RE: Revision to main and second floor framing for field Issue of over-bored holes in LVL above the owner's entry and above the pantry for Lot # 140 Woodside Ridge – 2118 NW Killarney Lane. Lee's Summit, MO 64081 – Permit # PRRES20210880

Revision to second floor framing shall be as follows:

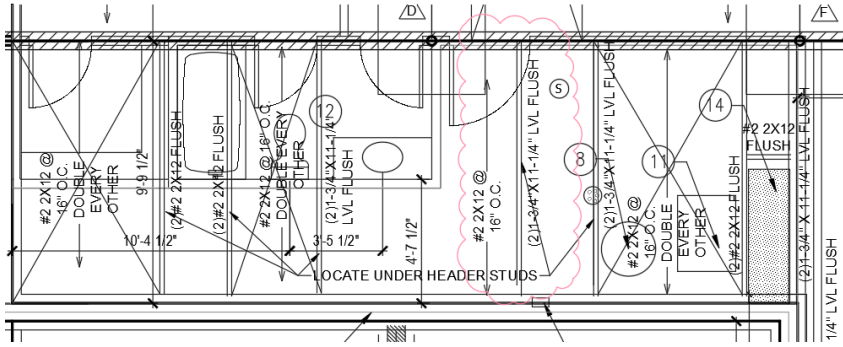
- Over-bored hole above owner's entry is approximately 3.5" diameter and located 2 ft from owner entry support for bed #1 toilet DWV.

- (2) 1-3/4" x 11-1/4" 3100 Fb Versalam LVL flush shall span approximately 7.5 ft with with 12 ft tributary width with standard floor loads of approximately 600 plf. End supports shall be (3) #2 2x4 at owner entry and (3) 2x4 jack studs at pantry header.
- Over-bored HVAC duct is approximately mid-span above the dropped LVL pantry header with a 6.5" diameter hole in LVL. Distance from HVAC chase to bottom of LVL is approximately 3.5".
- Install (2) 1-3/4" x 11-1/4" 3100 Fb Versalam LVL dropped header under over-bored flush LVL header for HVAC chase.
- (2) 1-3/4" x 11-1/4" 3100 Fb Versalam LVL dropped shall span approximately 3 ft with with 12 ft tributary width with standard floor loads of approximately 600 plf. End supports shall be (3) 2x4 jack studs at pantry header.

- Install (2) 1-3/4" x 11-1/4" 3100 Fb Versalam LVL flush spanning approximately 9.75 ft located underneath pantry/fridge support as shown in image below:
- End supports shall be foundation wall and W10x39 steel beam dropped.
